REVISED COPY

CONDITIONAL APPROVAL
PLAN APPROVAL EXPIRES: 04/08/2017

Eau Galle Cheese Factory
N6765 State Hwy 25
City of Durand, 54736
Pepin County

Object Type: Commercial Water Treatment Device Regulated Object ID No.: 1531451

Water Calc WorksheetEAU GALLE CHEESE FACTORY

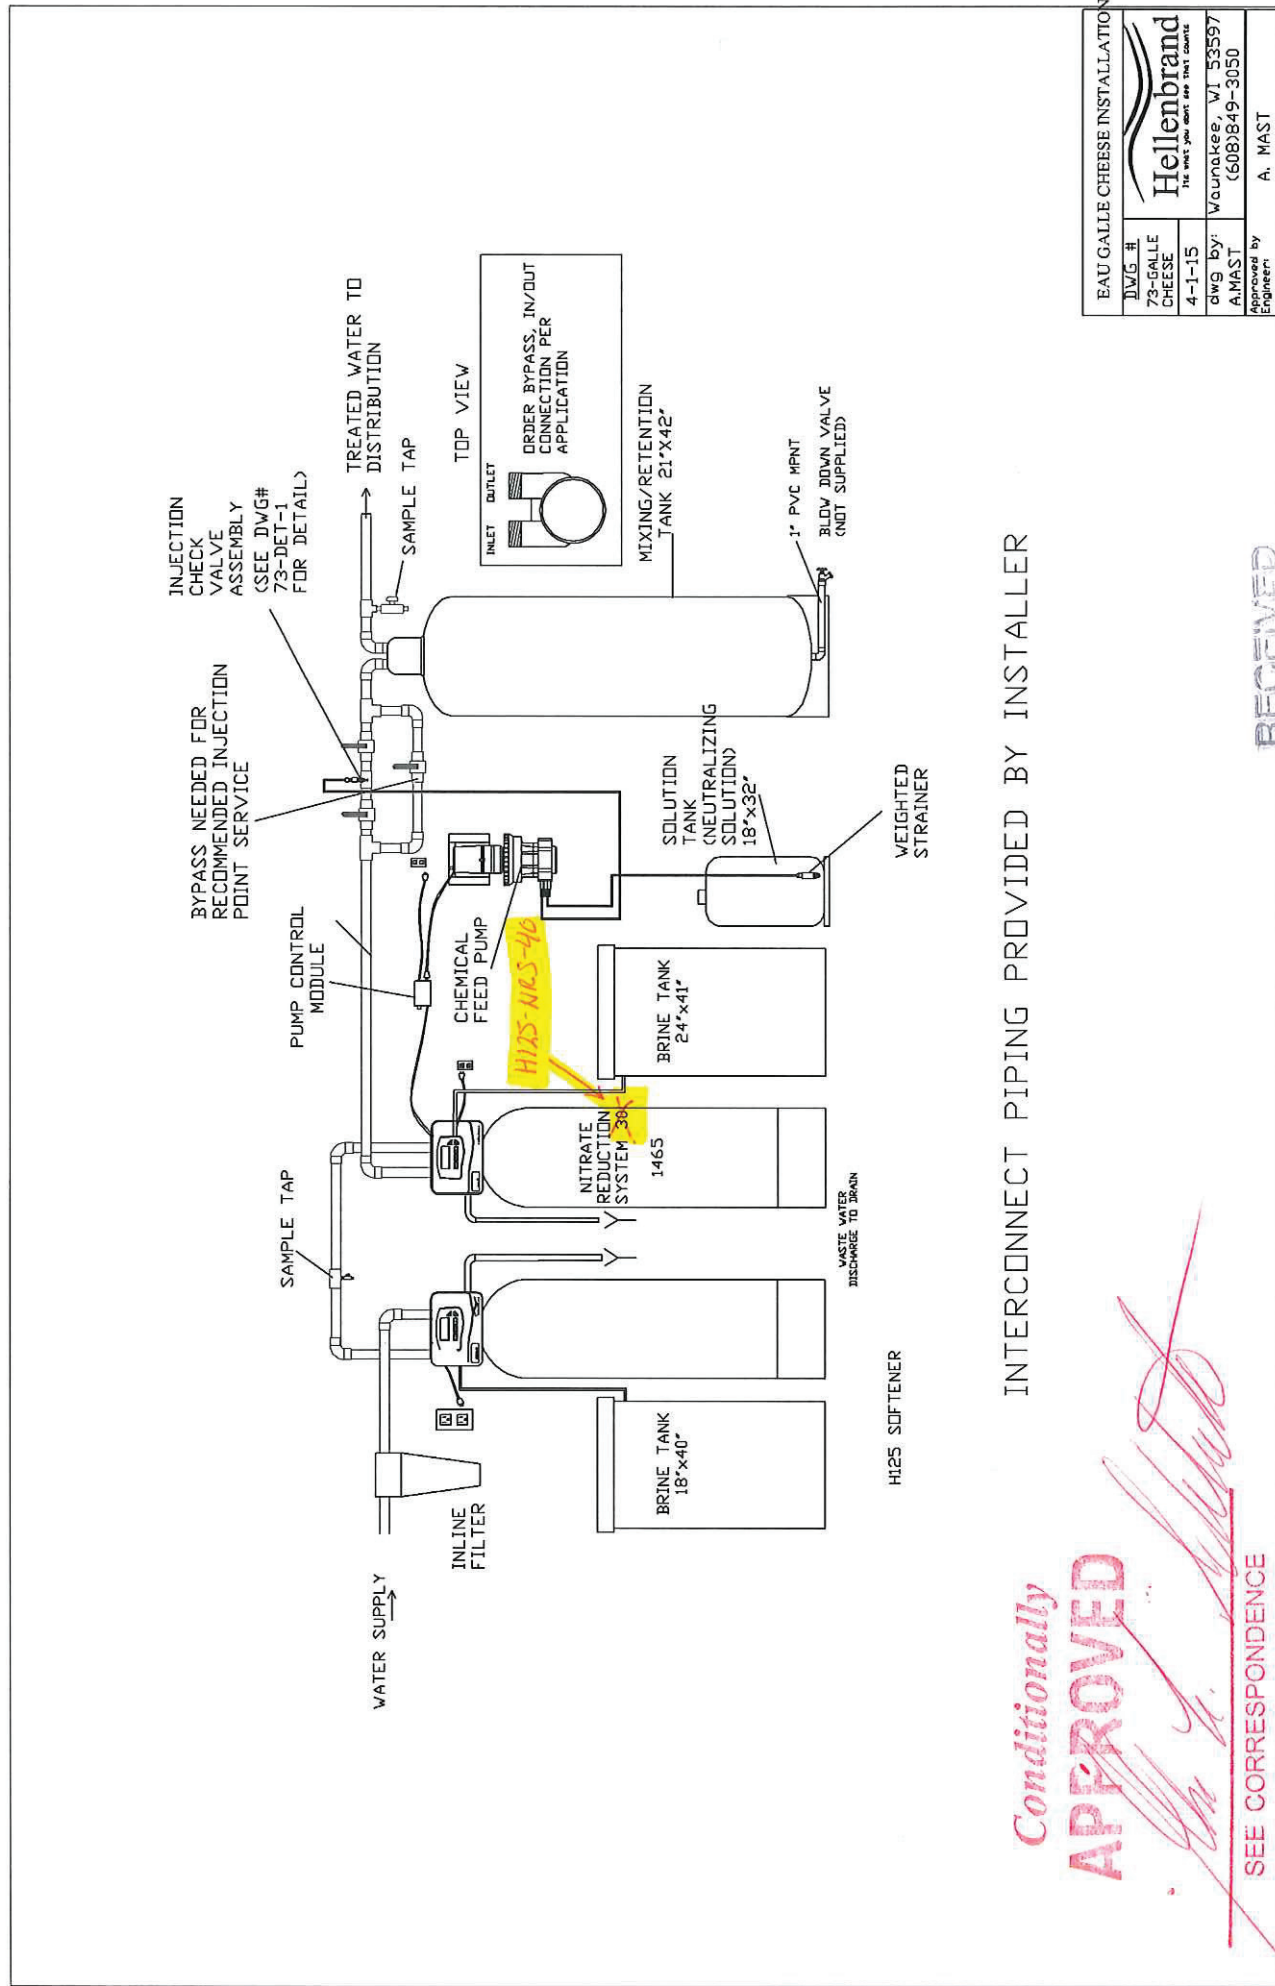
- No bypass piping shall be installed serving these devices. If a bypass is strongly desired, then it must be of the locking type.
- Flow controls shall be installed to prevent the device from exceeding its maximum rated service flow rate (i.e. 16 gpm). Note, the calculated building demand for this site is 17.2 gpm. The maximum rated service flow rate of the device installed is 16 gpm which means the device is mildly undersized. If it is found that the device installed cannot meet peak demand on a persistent basis, then the H125-NRS-40 shall be replaced by a H125-NRS-50.
